CITY OF ALBUQUERQUE

Re: West Mesa High School Classroom Bldg Erosion Sediment Control Plan Engineer's Stamp Date 4-16-15 (J10E005)

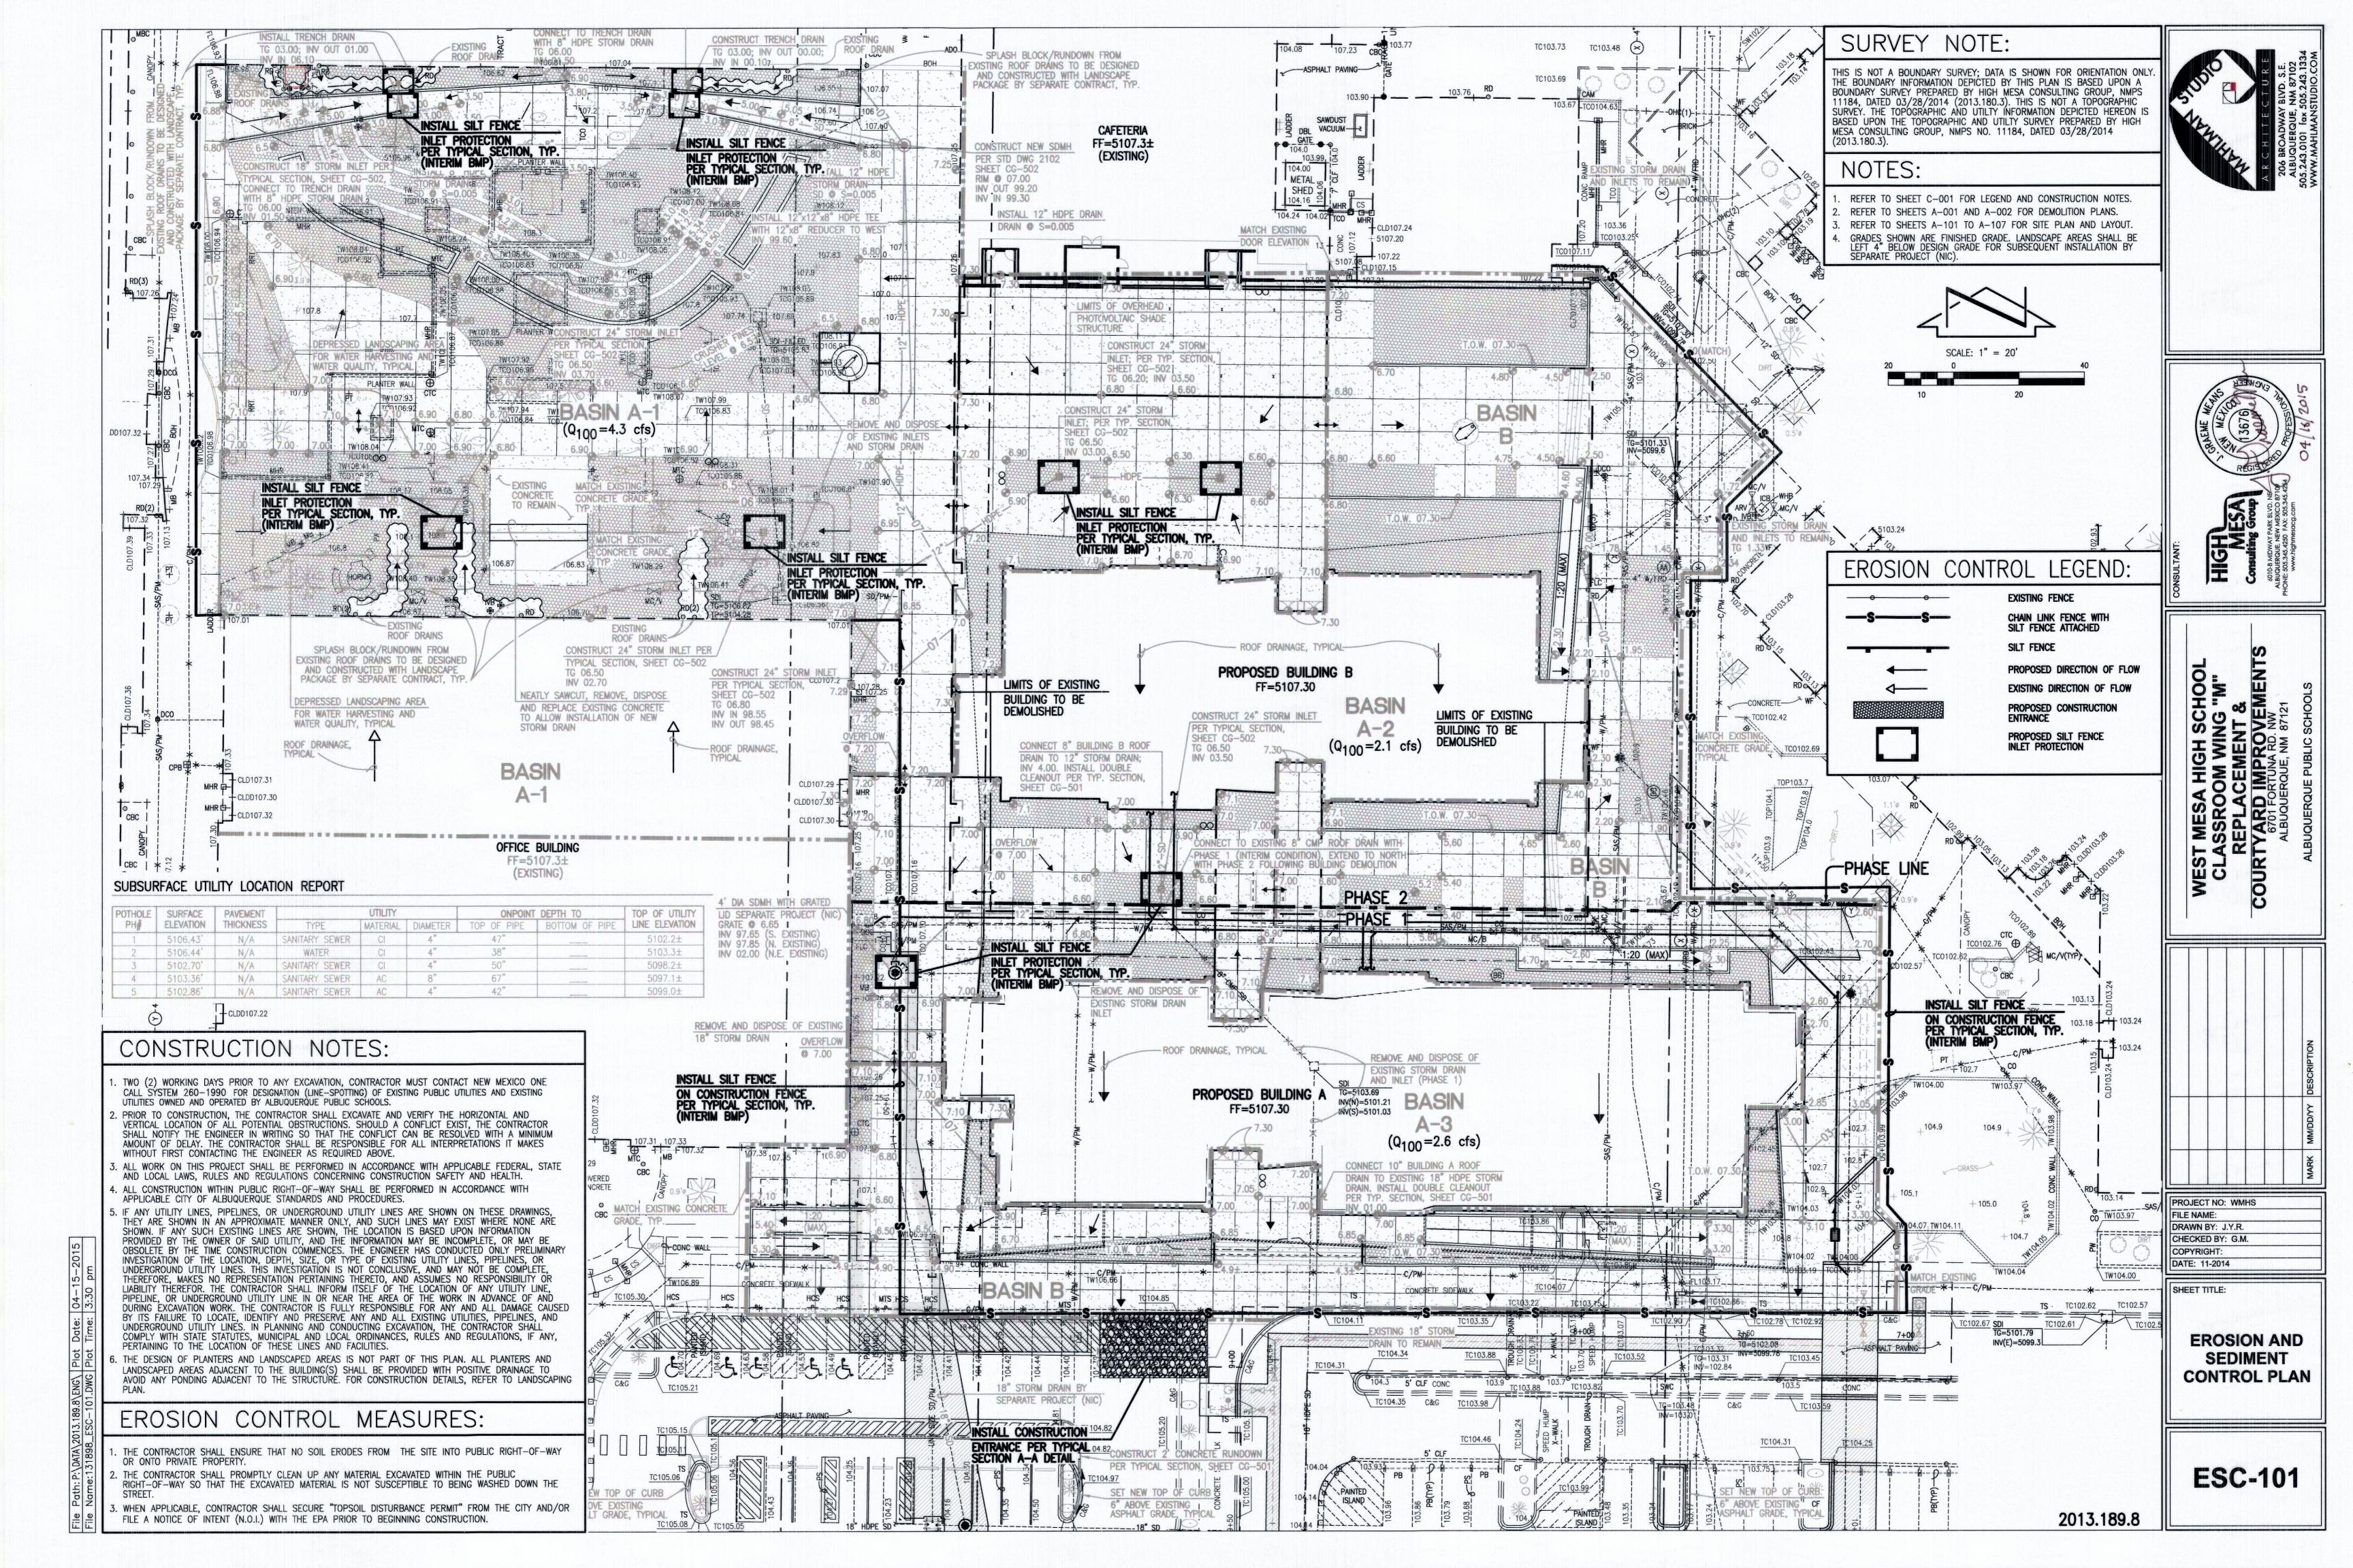
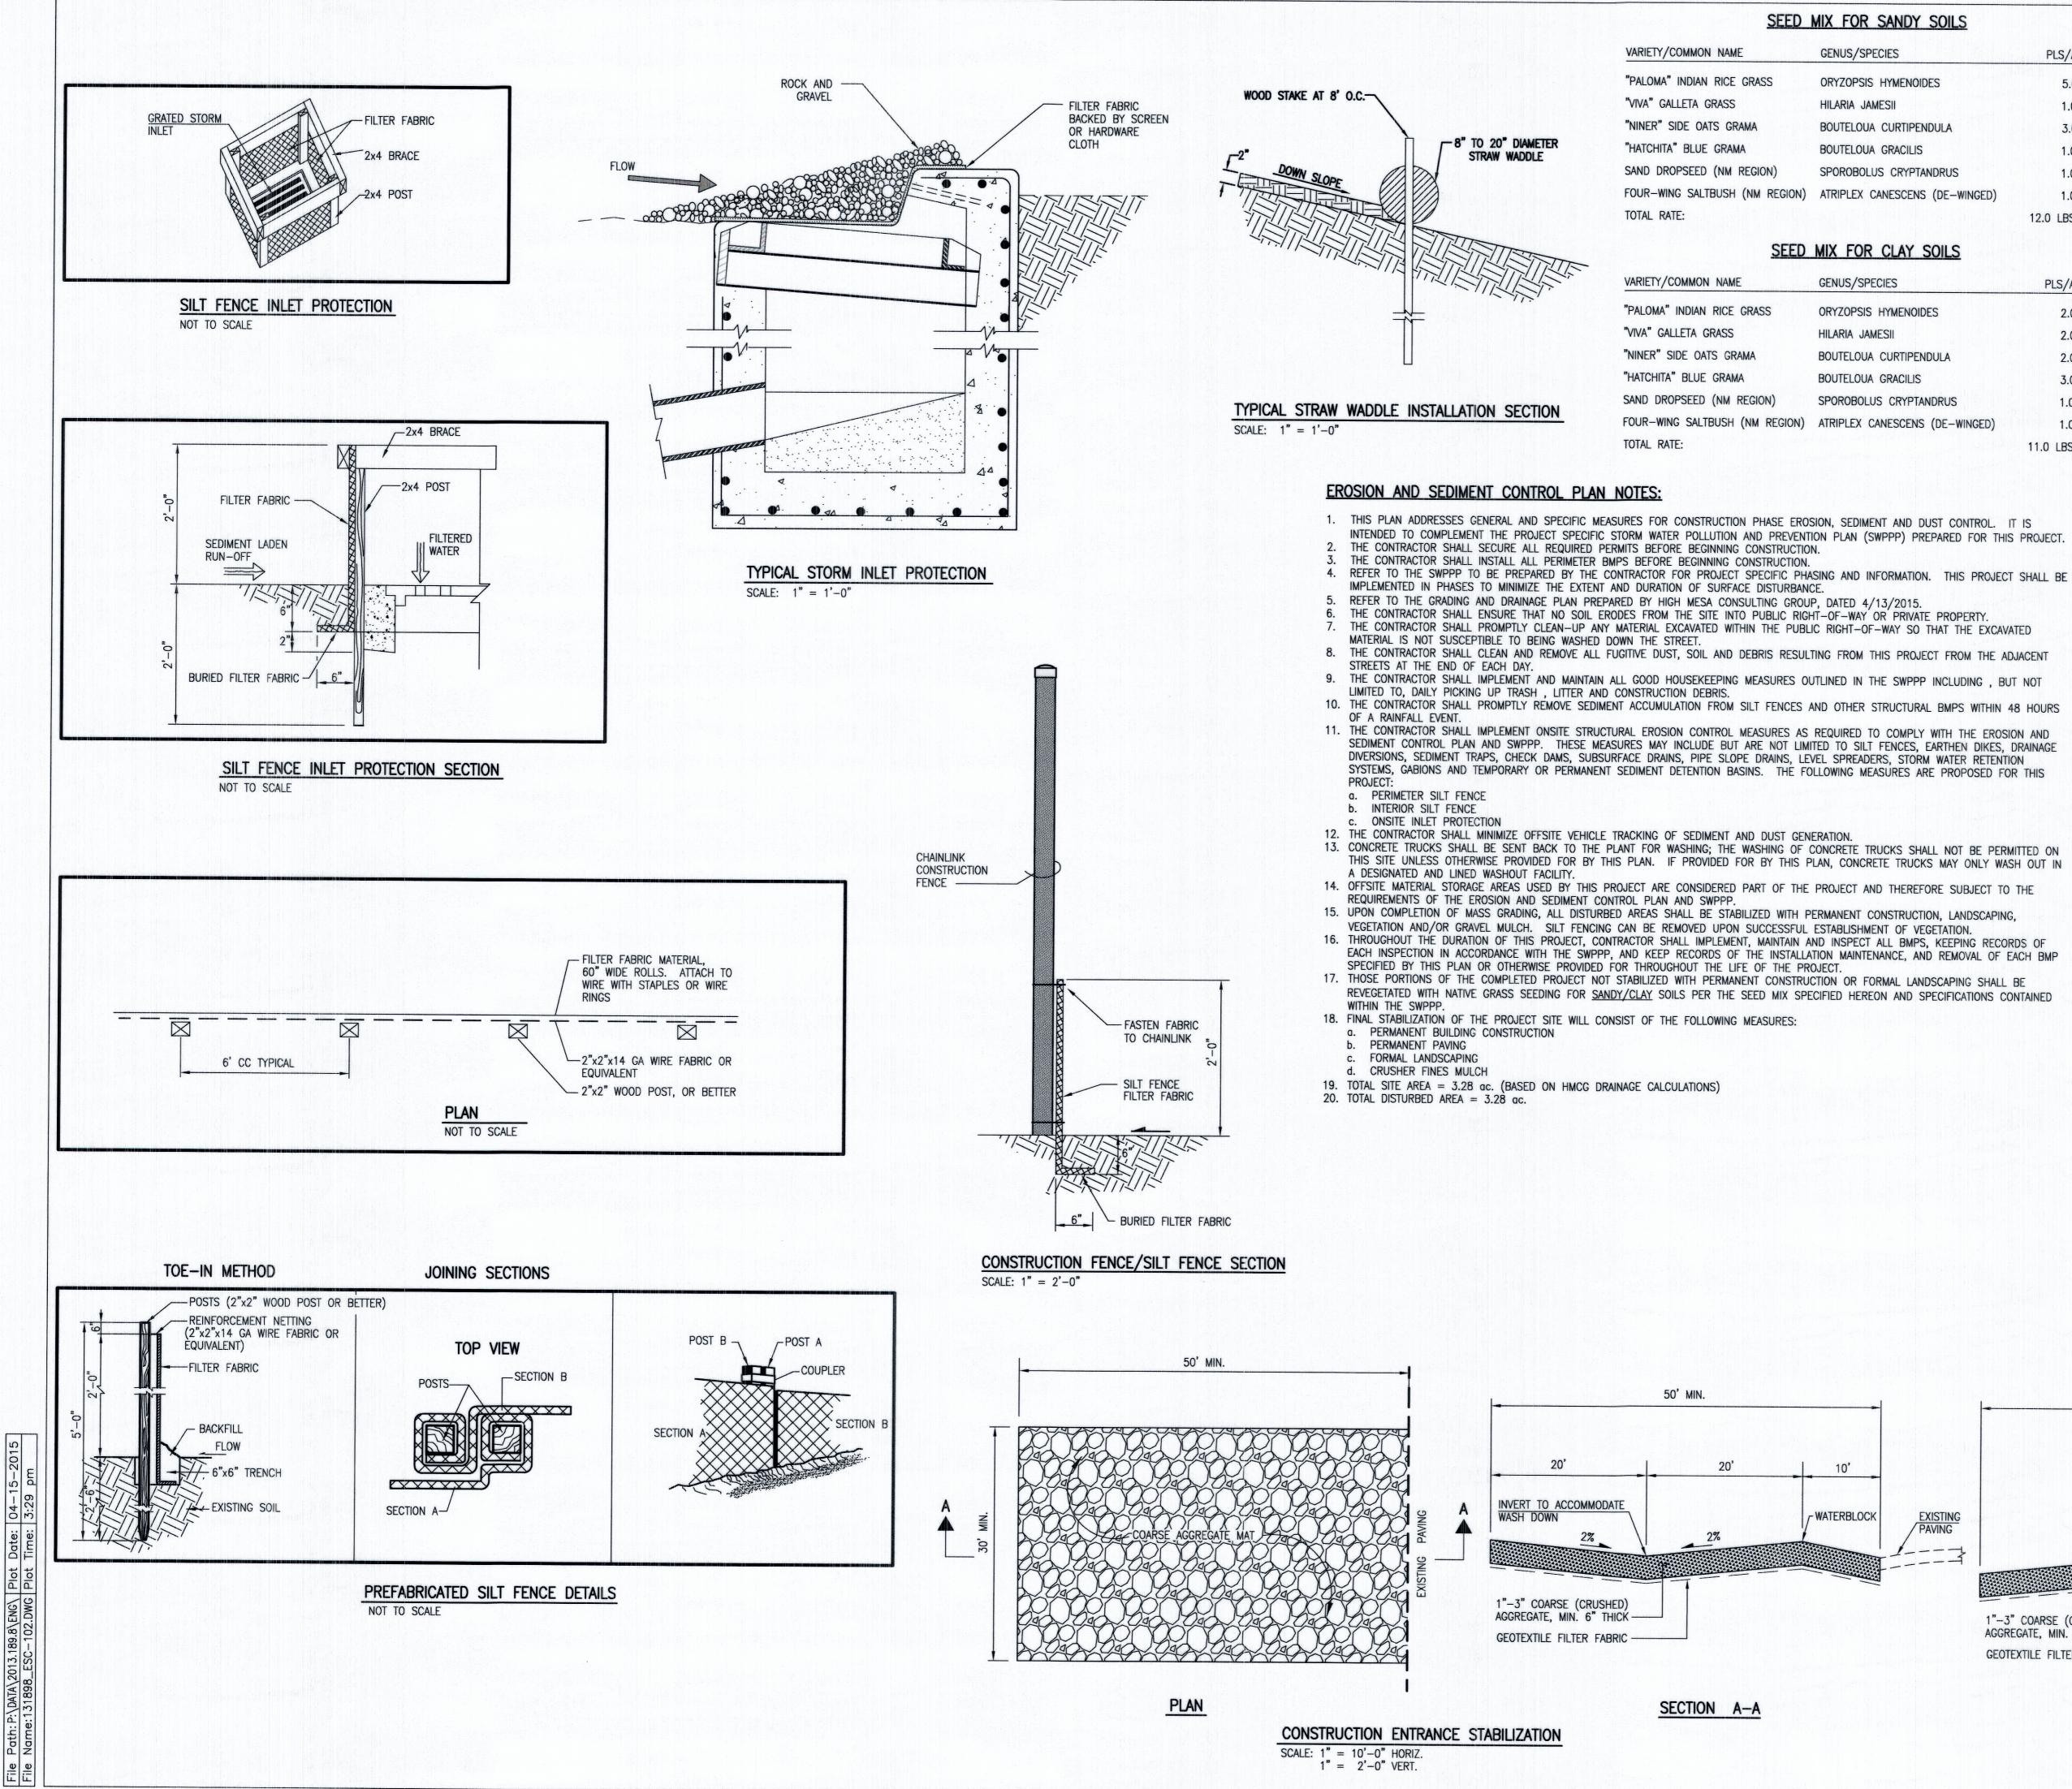
Based upon the information provided in your submittal received 4-16-15 the above referenced plan is acceptable to be included in the SWPPP and for Grading Permit/Building Permit once the grading plan is approved by Hydrology with the condition that inlet protection is provided for the inlet approximately 60 feet northeast of proposed Building B.
